Property of:
THE TECHNICAL MATERIEL CORPORATION
MAMARONECK, NEW YORK

SHIELD, RF TUNING CONDENSER

MS-2411 H

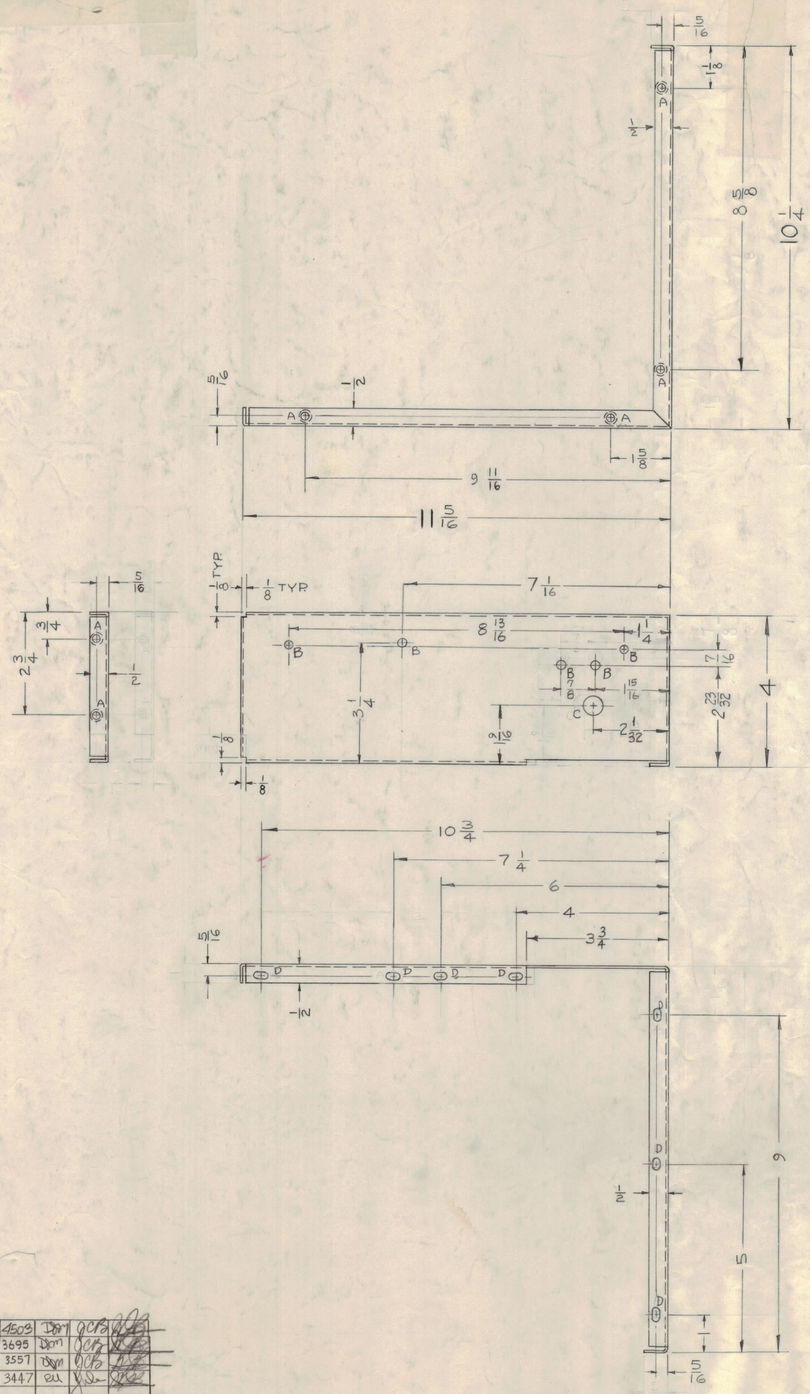
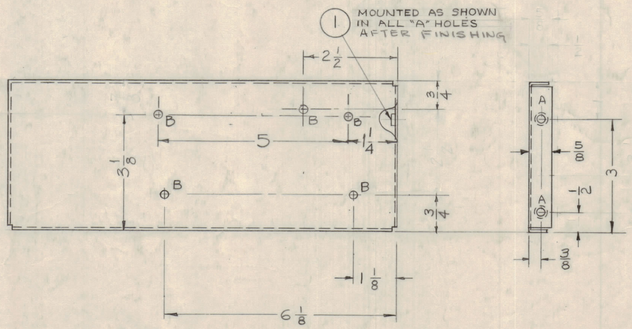
ISSUE	ZONE	DESCRIPTION	DATE	CH. NO.	DRAFTS	CHECKER	ENG. APP.
H	D7 C6 9	(17) "A" SLOTS WERE (7) "B" HOLES	3/29/61	4503	DBM	QC CB	
G	D7	Dim. 2 3/32 was 2 1/16; 2 1/32 was 2 1/64	12-9-60	3695	DBM	QC CB	
E	1	(4) "B" HOLES ADDED	11-29-60	3557	DBM	QC CB	
E	D8	① "C" HOLE ADDED	11-9-60	3447	BW	WC	
D	D8 D7 D3 C8 D7	SEVEN "B" HOLES WERE "A" HOLES 3/4 NOTCH DELETED 3 3/4 DIM. WAS 3 31/16 2 11/16 DIM. WAS 2 3/8	11-4-60	3373	WB	WC	
C	D7 C8	TWO "B" HOLES ADDED	10-18-60	3235	WB	WC	
B	C4 D4	NOTE ADDED 3/4 DIM. WAS 1"	10-17-60	8210	WB	WC	
A	D3	3/8 DIM. WAS 5/16	9-13-60	2951	CJS	WC
